## Development Special Use Permit #2021-10021

### 220 South Union Street – Hotel Indigo Parking Amendment

Application	General Data	
<b>Project Name:</b> Hotel Indigo Amendment  <b>Location:</b> 220 South Union Street  <b>Applicant:</b> Carr 220 South Union Street LLC, represented by Kenneth Wire, Wire Gill	PC Hearing:	September 9, 2021
	CC Hearing:	September 18, 2021
	If approved, DSUP Expiration:	September 18, 2024
	Plan Acreage:	21,299 sf (0.49 acres) *
	Zone:	W-1/Waterfront Mixed Use *
	Proposed/Current Use:	Hotel with restaurant and meeting rooms *
	Number of Rooms:	120 rooms *
	Net Floor Area:	61,182 SF *
	Small Area Plan:	Waterfront & Old Town
	Historic District:	Old and Historic
	Green Building:	LEED Silver or Equivalent
<b>Purpose of Application</b>		
Public Hearing and consideration of a request for an amendment to an approved Development Special Use Permit with site plan (DSUP#2012-00019) to modify the conditions of approval to permit greater flexibility regarding access, use and valet-assisted management of the underground parking garage

Figure 1: Parking garage layout: 40 self-parking spaces (in yellow) and 29 valet-assisted spaces (in green).

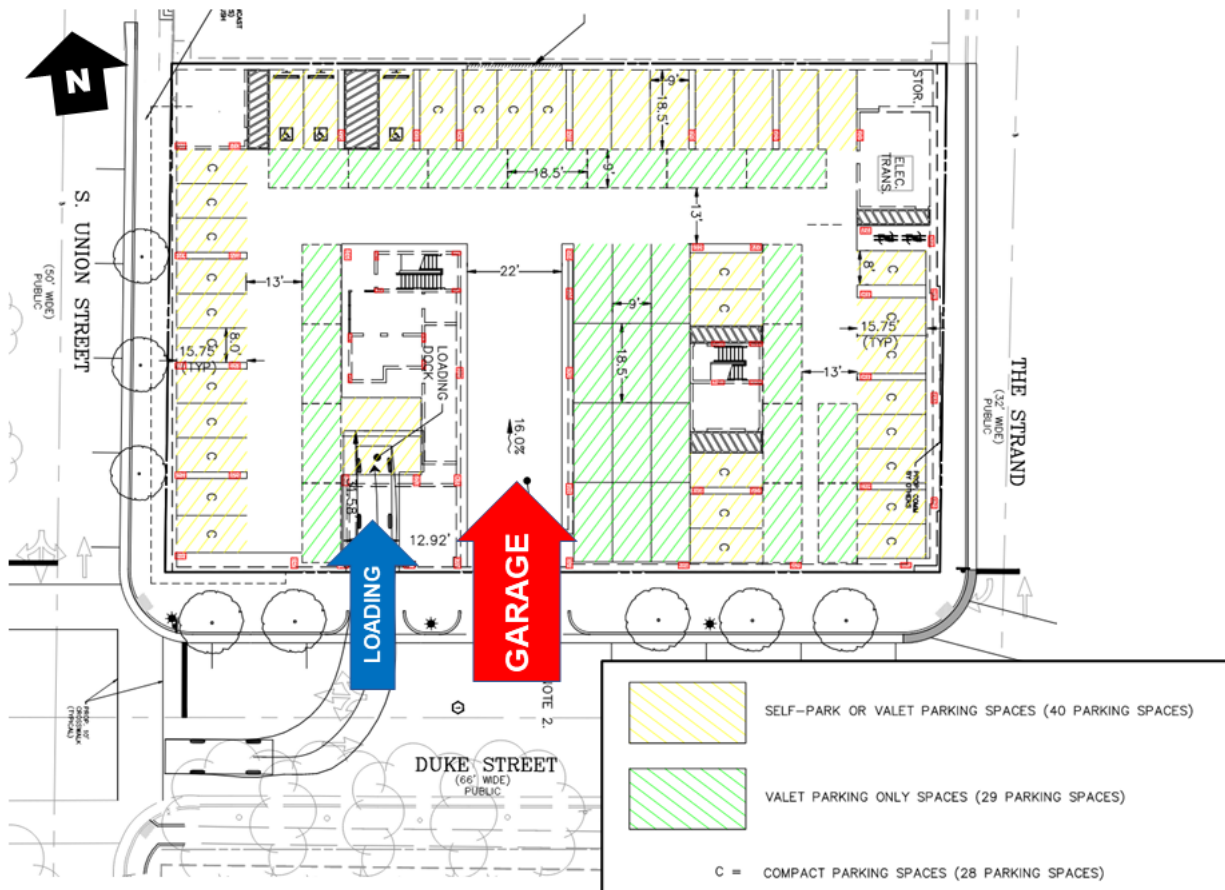
spaces (both self-parking and valet-assisted) will be available as long and short-term public parking.

The applicant will be monitoring the available parking via a parking access control system installed at the parking garage entrance. The access control system will provide information to the applicant on parking occupancy, which will inform the hotel operator when the valet parking service is needed to park cars and provide any customers with their cars in a self-parking or valet-assisted space. The maximum number of parking spaces in the garage (up to 69 spaces) will be managed by the valet operator. The parking management plan, required to be provided by the applicant pending approval during Final Site Plan, will provide additional details on self-parking garage access and the revised operations of the valet service.
